Feasibility Report - Final Environmental Impact Statement/Report Water Resources Investigation

Saugus River and Tributaries, Lynn, Malden, Revere and Saugus, Massachusetts

J - Feasibility Study and EIS/EIR **Comments and Responses** Section A

## FEASIBILITY STUDY AND EIS/EIR COMMENTS AND RESPONSES

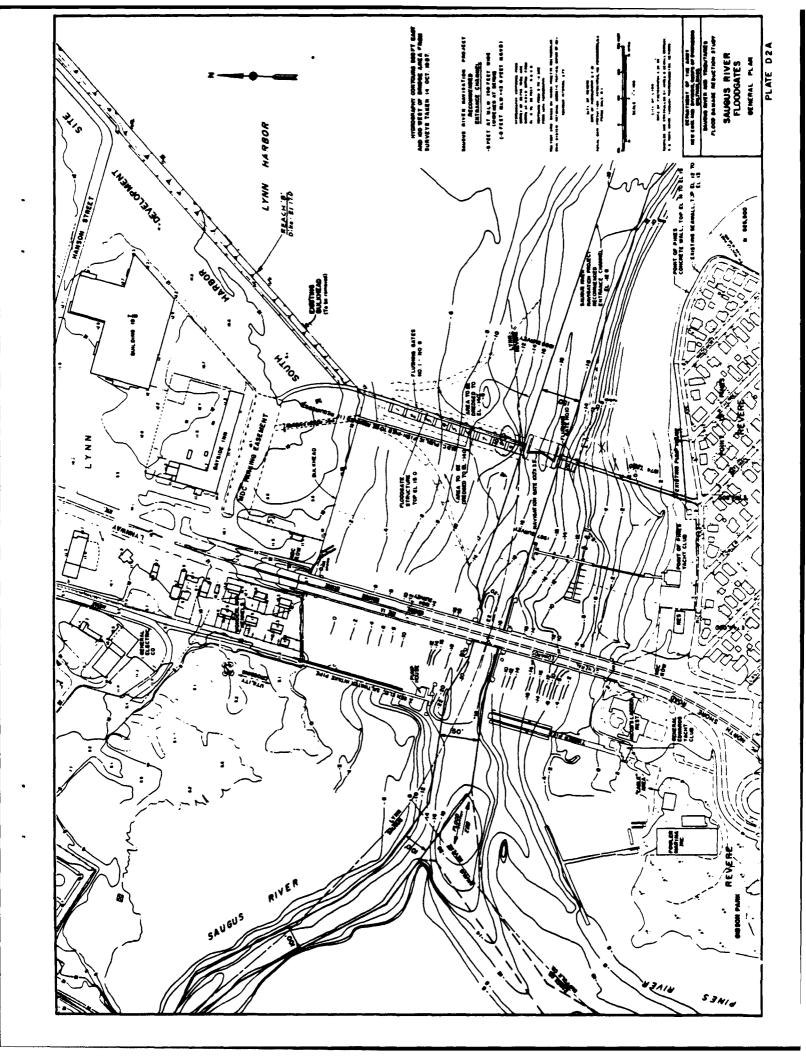
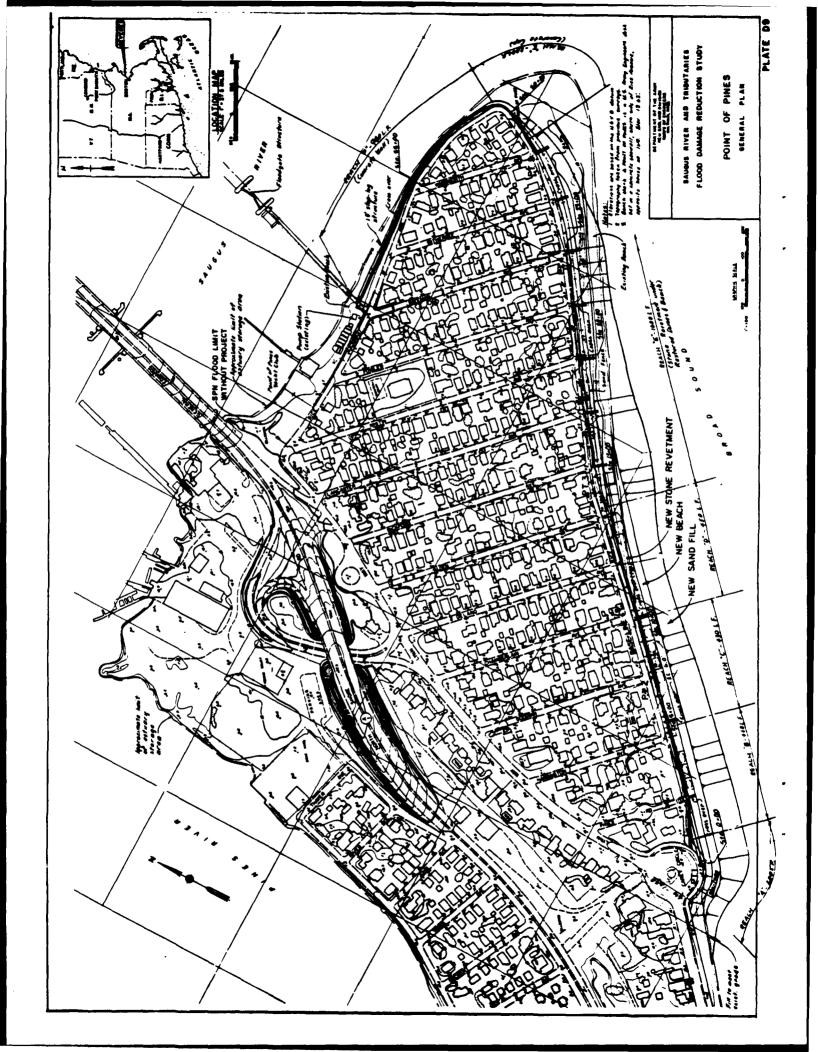
The original 165 foot long dike and 100 foot long I-Wall sections of the floodgate structure, which tied the gates into the Point of Pines walls, has been revised to an all gravity wall section on a straight alignment with the rest of the floodgate structure. (See revised Plates D2 and D2A). It was found that the gravity wall, in lieu of dike, would reduce the construction time by about 4.5 months.

- . the gravity wall eliminates a major concern for loss of beach from the original dike section expressed by the Mayor of Revere, City Councillor, Revere Planning office and residents at Point of Pines;
  - . the gravity wall reduces impacts on intertidal losses by 1.1 acres.

The gravity wall is therefore selected to replace the dike and I-Wall sections previously used. The straight alignment facilitates construction of the wall.

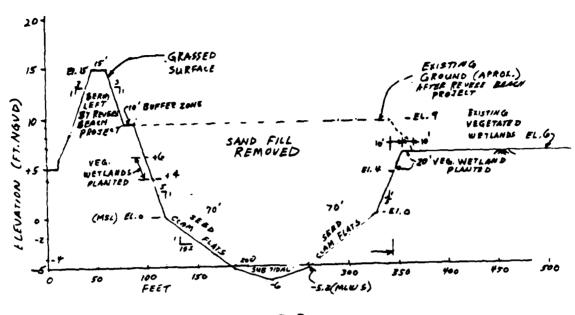
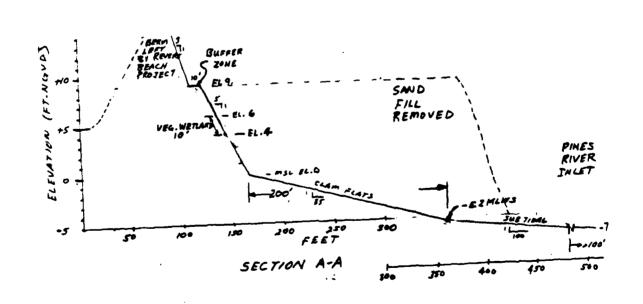
The proposed location of the mitigation site at the I-95 fill was relocated from near the Northgate Shopping Center to the northeast end of the fill near the Pines River, as shown on Plates D13 (revised) and D13A, away from the proposed location of the Revere Connector highway.

The revised profiles of the mitigation site are shown on Plate D13B. The 2.0 acre of intertidal flats are located in the most viable location within the range of the tides between mean tide level at approximately EL. 0 and mean spring low water at EL. -5.2. The 1.0 acre subtidal below EL. -5.2 runs through the center of the site. A fringe of vegetated wetlands would be planted between EL. 4 and 6 with an intertidal transition zone between vegetated wetlands and the areas colonized by clams. A ten foot wide buffer zone is located between the berm at EL. 15 and the side slope of the vegetated area. The berm would be used for inspection access around the site. The total acreage of the site which would average about 850 feet long and 330 feet wide is:

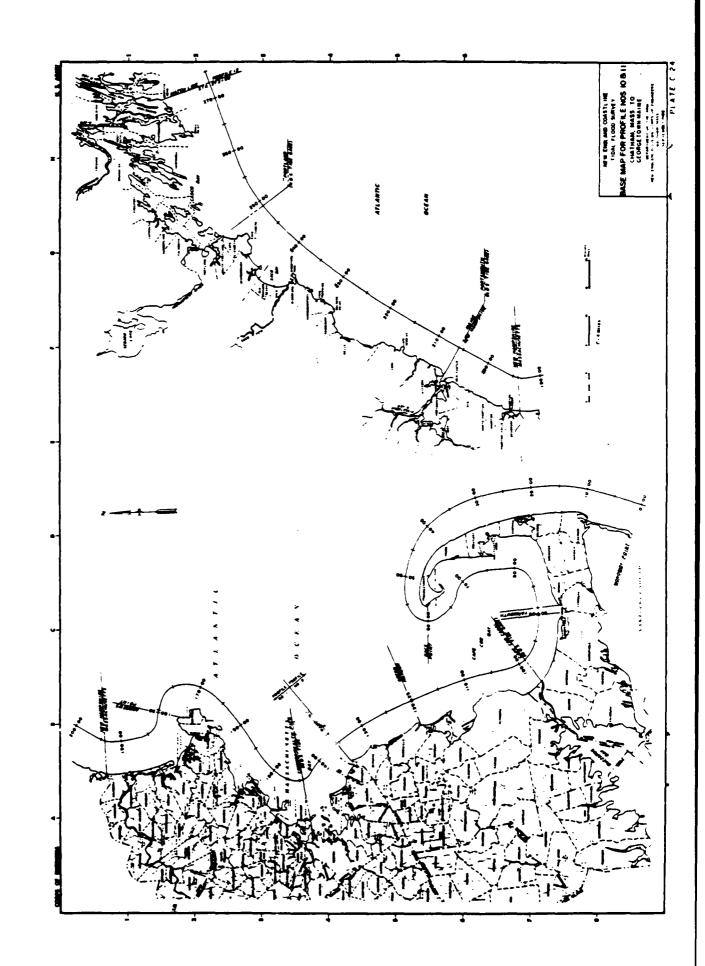
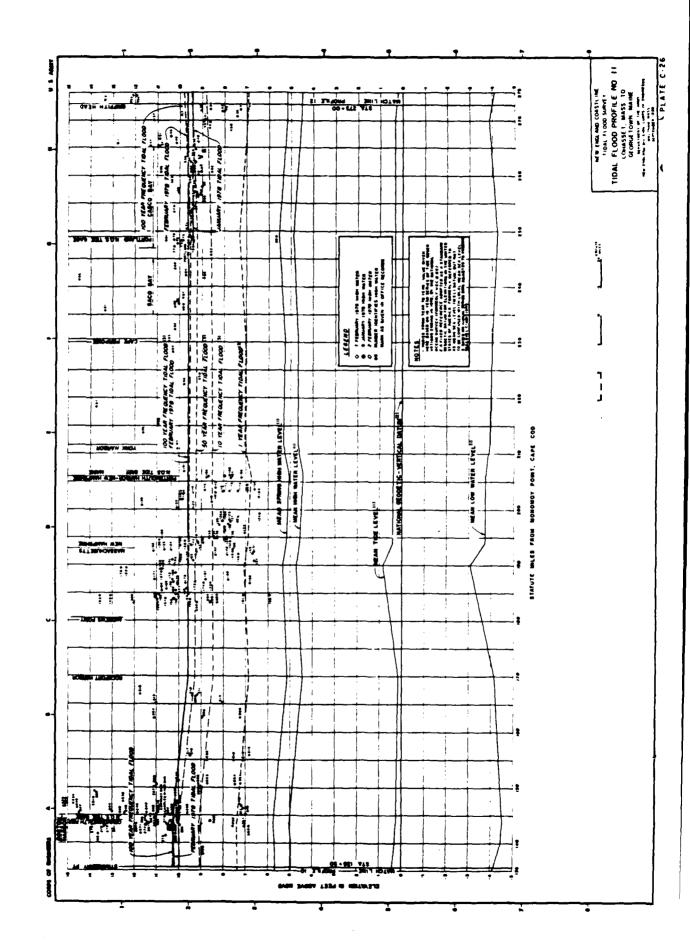
D By preventing a storm surge up the river with building of the dike will this cause an increase in the force of a storm that will have detrimental affects to the oceanside of the

@ will the building of the dike affect; the present estury (ie, sellicity, etc); present currents of the Troer ; proent corrents moving North on Revere

3) The building of the dike regular land to king, what is Herms of compensation will the O land owners receive?
